Iowa City Planning & Zoning Commission

Formal Meeting
Thursday, November 5, 2015
7:00 PM

Staff Reports

Date: November 5, 2015
To: Planning and Zoning Commission
From: Karen Howard, Associate Planner
Re: REZ15-00020 600 Block of S. Dubuque Street

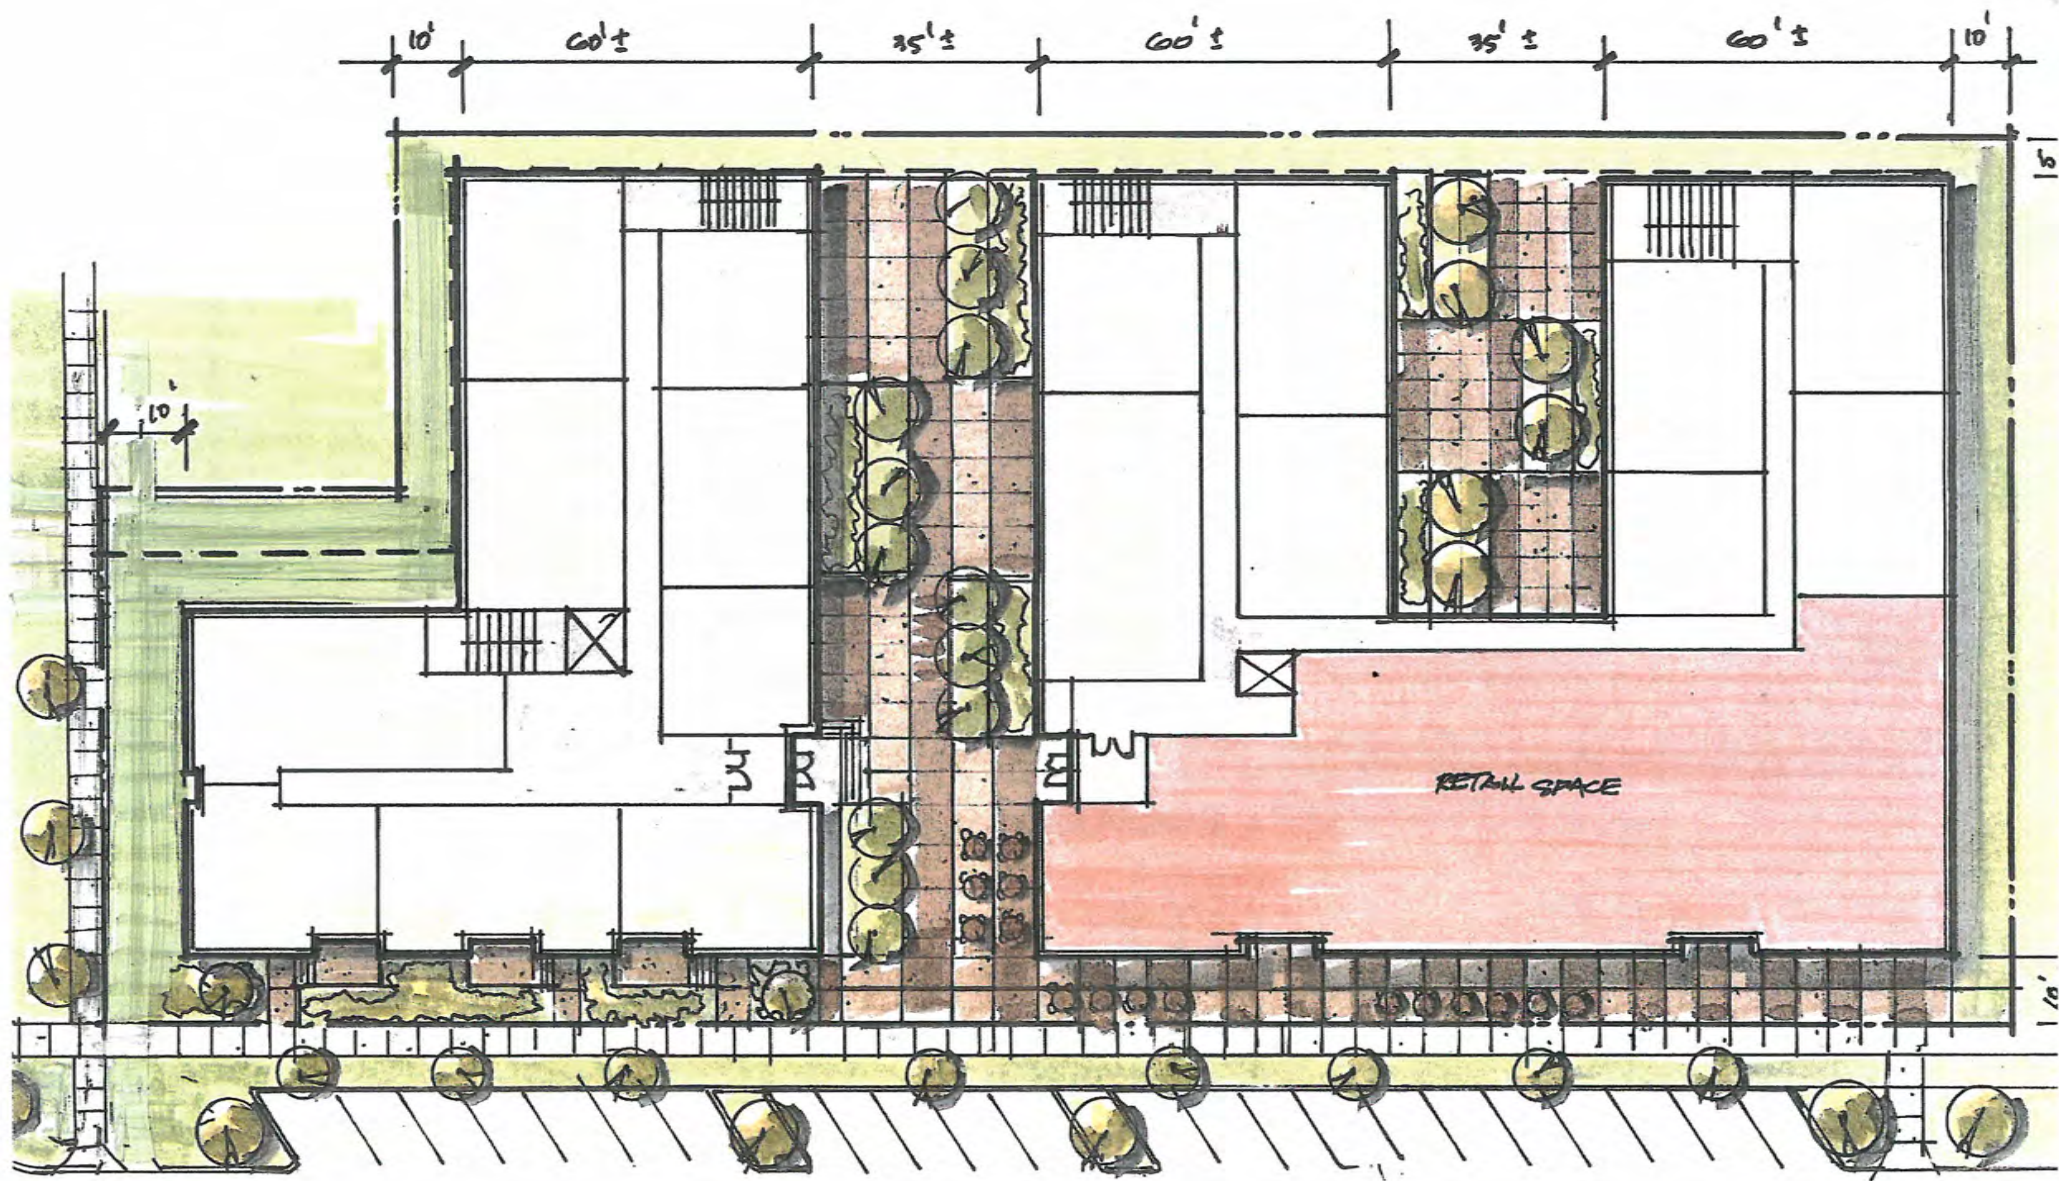
Staff has reviewed the submitted site plan and building elevations in relation to the applicable goals of the plan. Most relevant are the goals to encourage contextual infill, building on efforts to improve quality residential design, promote new housing options, provide a mix of residential and retail uses, and leverage future investments in transit.

The site plan shows two buildings that will likely share below grade structured parking accessed from the rear alley. The steep topography of the site will make it easier to provide below grade parking that will be hidden from public view along the street frontages. The L-shaped building to the north will likely be a 4-story multi-dwelling building. The code will require the 4th story to be stepped back a minimum of 10 feet along both street frontages. Between the two buildings a minimum 35-foot-wide "pedestrian street" is proposed that will be designed as usable shared open space between the two buildings. The building to the south will be required by Code to be a mixed-use building with commercial space on the ground level floor. The lot size and configuration makes a U-shaped building an attractive choice as it will provide the maximum façade area to provide generous window coverage for upper floor residential uses. The lot size will allow two 60-foot building wings and a 35' wide rear courtyard that can also be designed for shared use by the residents. With this type of configuration most units will have views toward the street, the shared interior courtyard or of the private pedestrian street between the buildings. Units on the south will look out over the 80-foot-wide railroad right-of-way, which will ensure light, air, and views are maintained to the south.

The conceptual building elevation indicates how recessed areas and the open pedestrian street will help to break up the mass and scale of the buildings along Dubuque Street. The form-based code includes fairly extensive standards to help ensure quality residential design. The code provides a menu of allowed frontage types (portico, stoop, or terrace) that are allowed for residential buildings. The frontage types include detailed design standards to ensure that entranceways are configured with appropriate architectural features and recessed doorways. Front yard landscaping is required by code in areas that are not used for entryways and the relationship between the private frontage area and the public space along the street is also laid out in the code. A minimum 6-foot sidewalk and street trees will be required. On-street parking may be allowed with agreement by the City to help the required retail be successful. The south building will be required to meet the storefront frontage requirement that includes 70% transparent window coverage, at grade entranceways at least every 50 feet, and canopies or awnings that extend across a minimum of 60% of the length of the storefront façade. The minimum upper story window coverage for street-facing facades is 25%. There are also specific requirements for building modulation and articulation in the form-based code to prevent long flat facades with little visual interest. Blank walls greater than 15' in length are not allowed in areas within public view.

It should be noted that the site plan and building elevations submitted are conceptual in nature, so details have not yet been determined. However, the form-based code includes a fairly extensive set of building design standards that must be met and all new buildings in the Riverfront Crossings zones must be approved through the design review process. Additional standards of note beyond what is mentioned above include window type and design, entranceway design, minimum floor to ceiling heights, exterior buildings materials, and location and screening of mechanical equipment. In addition there is an open space requirement that ensures that a minimum amount of shared private open space is included on each property. There are standards in the code that ensure that this space is designed to be usable shared space, while maintaining privacy for individual units.

park. The proposed zoning will also ensure that opportunities for neighborhood-serving retail uses will be provided. However, as stated in the original staff report, we recommend that additional open space be required beyond what would be required to meet the minimum open space requirement in the form-based code. This block-long redevelopment will be more contextual with the surrounding neighborhood character if the building is broken into two buildings and more generous usable courtyard and pedestrian areas between the buildings and within the rear courtyard is provided. This additional open space will help create higher quality living space for the higher density residential development anticipated with the rezoning. The applicant's site plan illustrates how this can be achieved on the property. To ensure that the additional open space shown on the conceptual site plan is provided upon redevelopment, staff recommends the following condition:

- Mid-block shared, useable open space is required between the buildings and between building wings as conceptually shown on the submitted site plan. The mid-block space between the buildings must be at least 35' wide and must be designed as a "private pedestrian street" as set forth in the form-based code and also meet the design standards for "open space" as set forth in the form-based code. Courtyard space between building wings must be a minimum 35' in width and must be configured as shared usable open space meeting the design standards in the form-based code.
